Attachment 1 - PLN17/0833 - 69-71 Smith Street, Fitzroy - Plans and Elevations

Attachment 3 - PLN17/0833 - 69 - 71 Smith Street Fitzroy - Heritage advice

To: Lara Fiscalini
From: Artemis Bacani
Date: 7 May 2018
Subject: Application No: PLN17/0833
 Description: Construction of a Triple-Storey Building - Restaurant
 Site Address: 69-71 Smith Street, Fitzroy

69-71 Smith Street, Fitzroy Development Application Acoustical Review

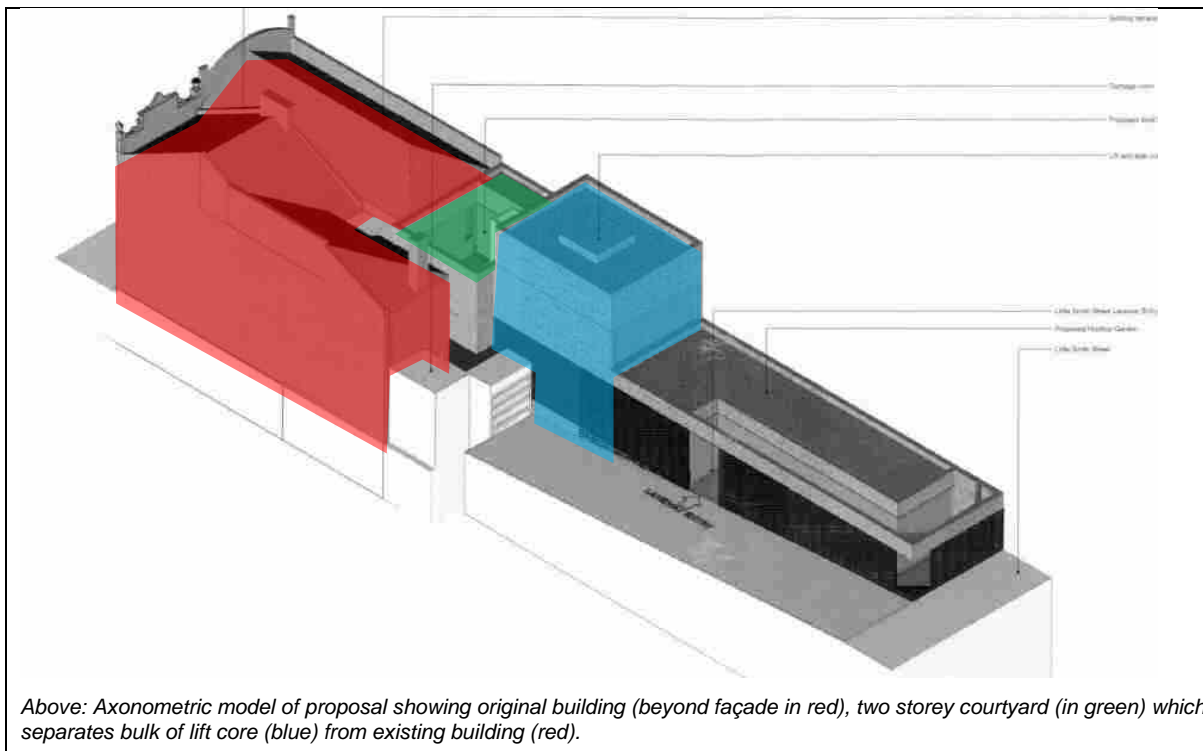
- The proposal includes removal of the concrete floor at No.71 Smith Street. The concrete floor is not original and will be causing damp issues for the original walls (by pushing ground water away and not allowing the subfloor to ventilate). In accordance with the above mentioned clauses, it is highly recommended that the floor in No.71 Smith Street be replaced with a timber floor which will have better ventilating properties underneath. Depending on available room, a raised timber floor may also offer concealment of electrical wiring etc.
- **Demolition of the remaining early-twentieth century metal shop front framing and flanking tiled pilasters is not supported**, as it will diminish the historic appearance and integrity of the individually significant building. The remaining original fabric should be retained, repaired and incorporated in a sympathetic new shopfront design.

No works are proposed for the building façade, however it is assumed that the existing graffiti on both façades and bluestone at No.71 will be removed.

As stated earlier, the proposed new shopfront for No.71 Smith Street is not supported and must be redesigned to retain the surviving original fabric.

- 1) That the remaining early-twentieth century metal shop front framing and flanking tiled pilasters associated with no. 71 Smith Street must be retained, repaired and incorporated in a sympathetic new shopfront design in keeping with the architectural style of the remaining shopfront elements;
- 2) That removal of paint from originally unpainted masonry components must be carried out as part of the proposed external works to the building façade via chemical peel process and light water spray only. Do not sand blast or use heavy jet sprays. Where repointing is required, use only mortar in accordance with AS3700 mortar class M2 and ensure mortar colour and aggregate matches original;
- 3) Reinstate a timber floor to ground level of No.71 Smith Street.
